## Cambridge City Council

## PLANNING COMMITTEE MEETING – 6<sup>TH</sup> JANUARY 2016

### Amendment/De-brief Sheet

Attachment 1 - Applicant's proposed road and access design

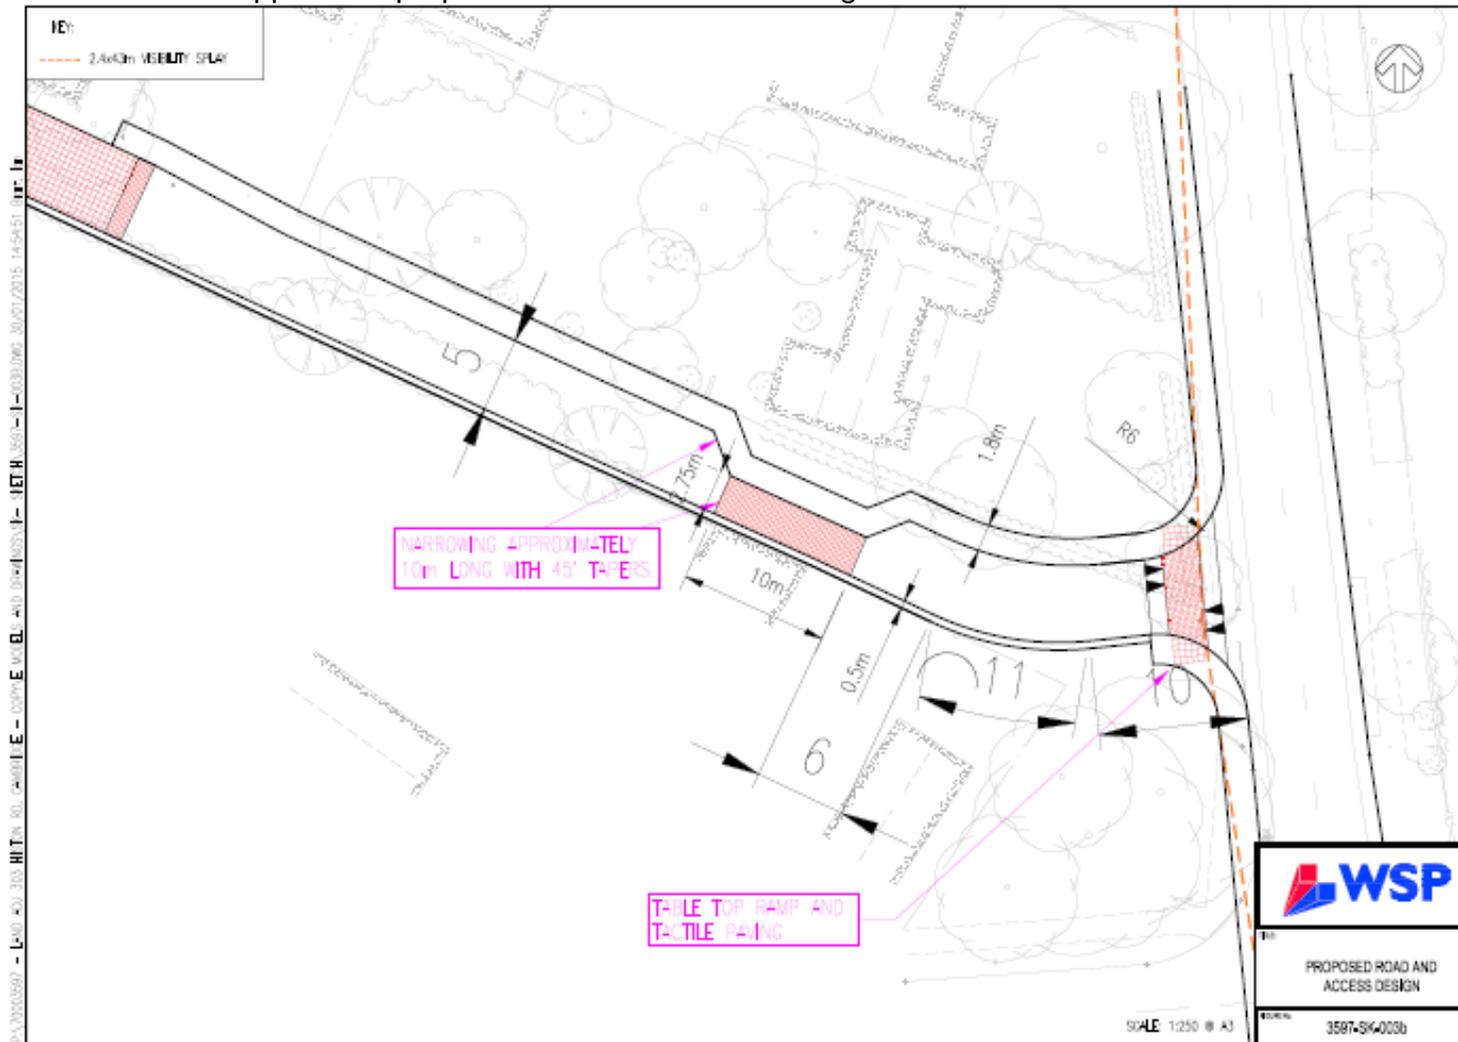
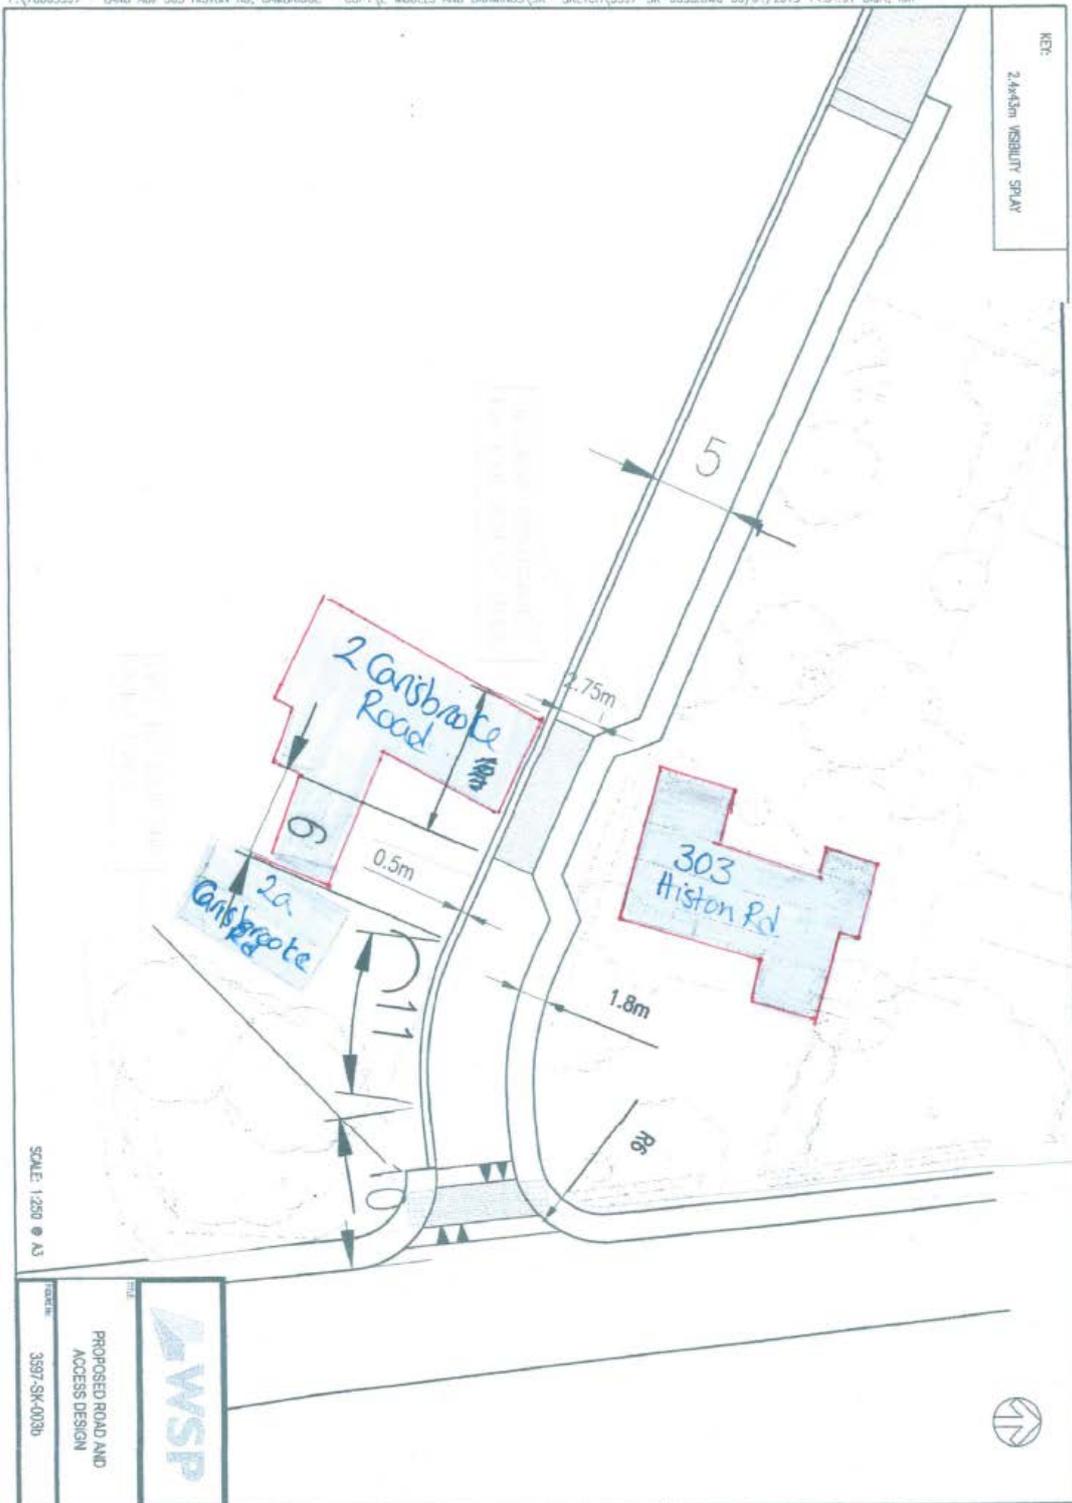
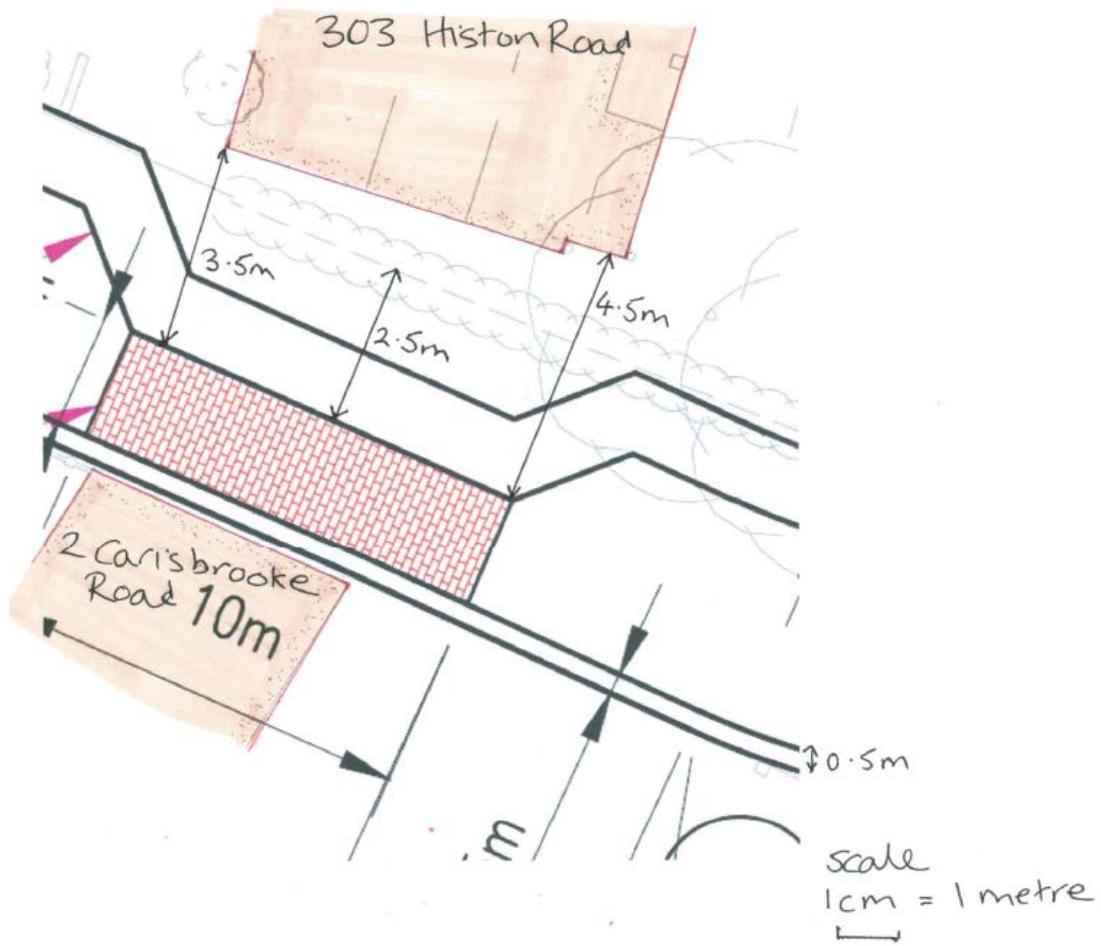
The 'Proposed road and access design' for which the applicant is seeking full planning permission disproportionately disadvantages 2 Carisbrooke Road.

2 Carisbrooke Road is the only house that abuts the access lane to the proposed houses. However, alongside 2 Carisbrooke Road is where the applicant is proposing narrowing the road and positioning traffic calming. We strongly object to this as it forces all incoming and all exiting traffic along our house wall, with the associated noise and vibration. We understand it is unusual to put an adopted road and traffic calming up to a house.

We suggest that any traffic calming is moved further (West) down the lane so that it does not abut any building.

**We ask that, if conditional consent was to be issued, the Council impose a condition requiring the applicant to submit amended proposals for the access lane which would be considered as a Reserved Matter after taking into account the needs of the residents of the properties abutting the lane.**

The plans submitted with the application were misleading as they failed to show the existence of an extension to 2 Carisbrooke Road that, as far as we are aware, was constructed at least 40 years ago. This extension immediately abuts the lane. In particular the location of our home in relation to the proposals is not clear from the applicant's proposed road and access design drawings. The applicant has omitted the extent of our home and positioned the measurements of the proposed 10m traffic calming zone over the small part of our house that they have shown.

With regards to these issues, the applicant's agent has proposed to amend the plan to cover the access to the highway only and omit the remainder of the access road from the details at this stage. I considered the original access details to be acceptable in highway safety and neighbour amenity terms. However, I also consider the proposed revised details to be acceptable and therefore recommend approval on the basis of this proposed amendment.

Title  
Block A – Floor Plans

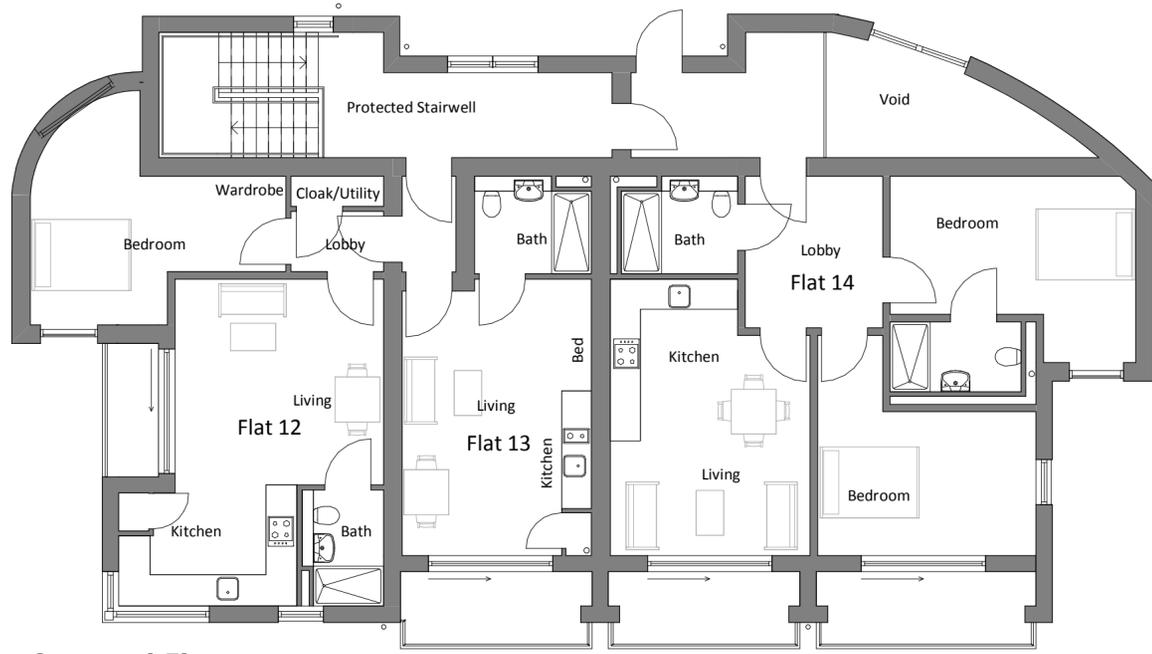
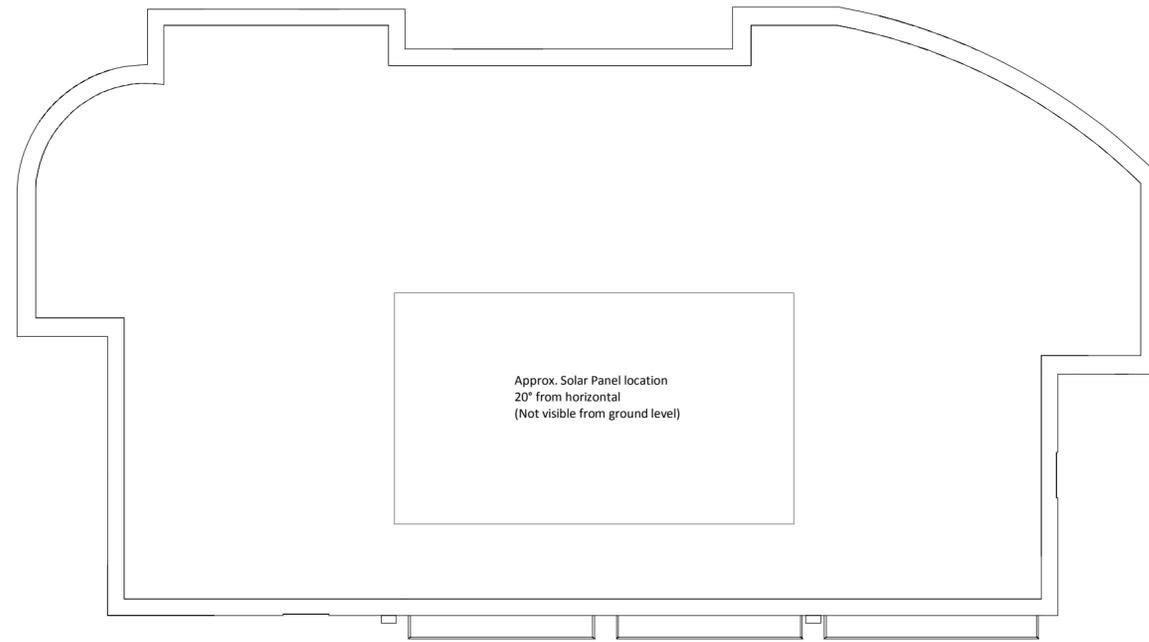
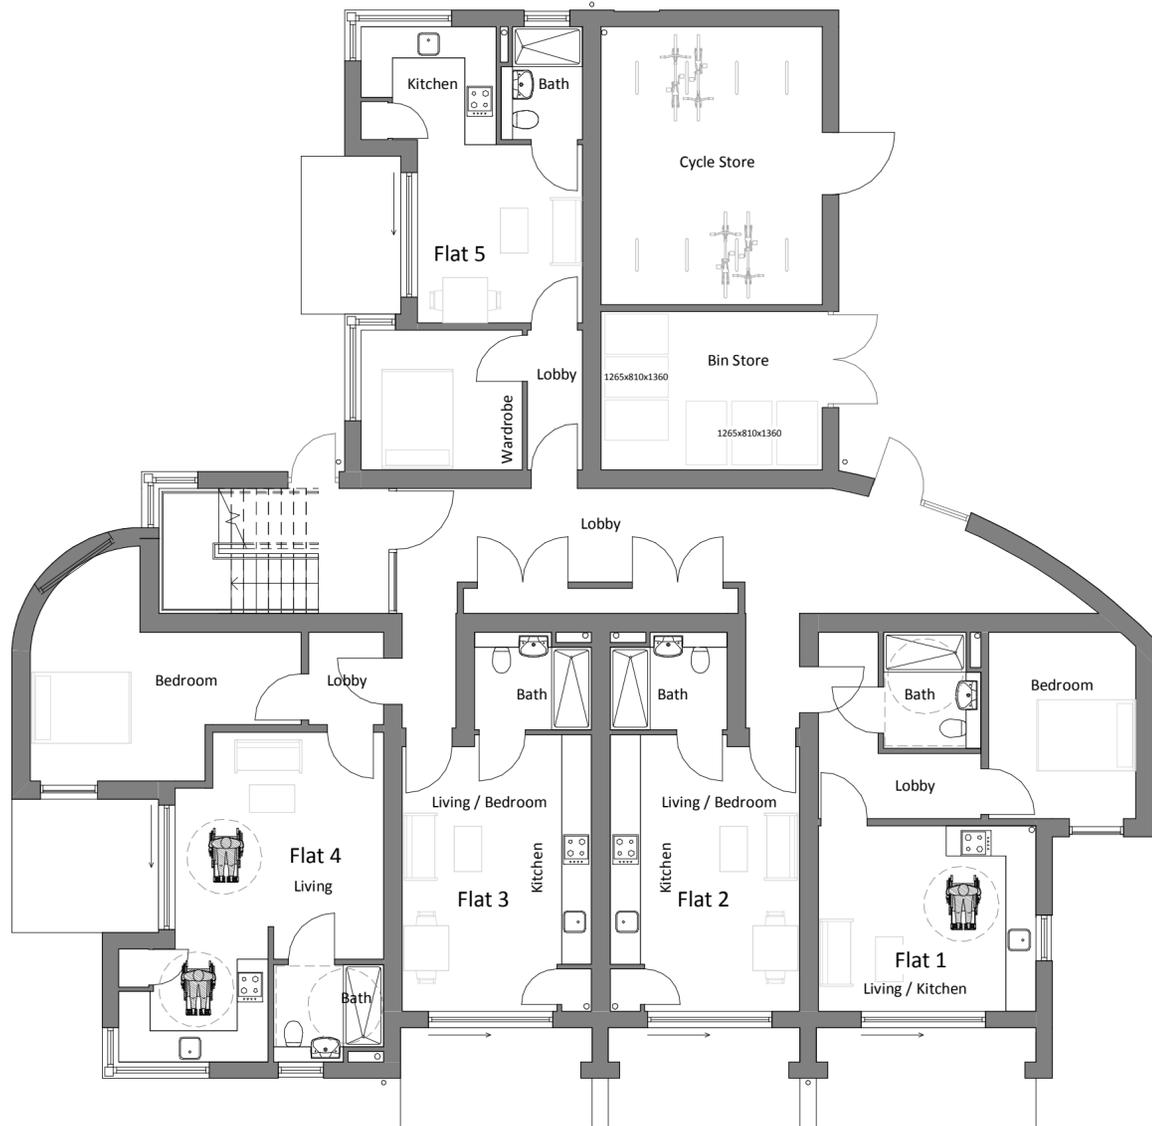
2. An amended ground floor plan has been received for Block A – please see Appendix 2 of this amendment report (plan A(20)01 Rev C). This has 'handed' Block A Flat 5 and the refuse and bin stores to provide west-facing decking and private garden space to Flat 5 and make the bin and cycle stores more conveniently located to the block entrance. Overlooking is retained by flats above and opposite, avoiding concerns of 'lack of activity'. The proposal is acceptable to the urban design officer.
